Our Case Number: ABP-313892-22

Re: Bus Connects Blanchardstown to City Centre Core Bus Corridor Scheme
Blanchardstown to Dublin City Centre

Blanchardstown to City Centre Bus Connects

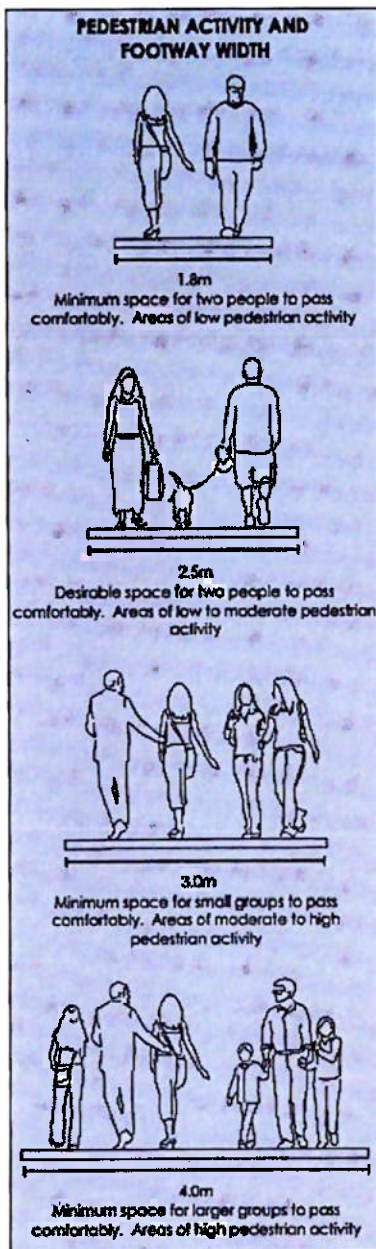
The manual references the UK *Pedestrian Comfort Guidance for London* and the associated figure below.

Accordingly, this figure clearly shows that the footpath environment at 136-142 Navan is not purely residential and is currently aligned with the third scenario for 3.0m width due the presence of the bus stop, schools and care homes. I also note the manual states:
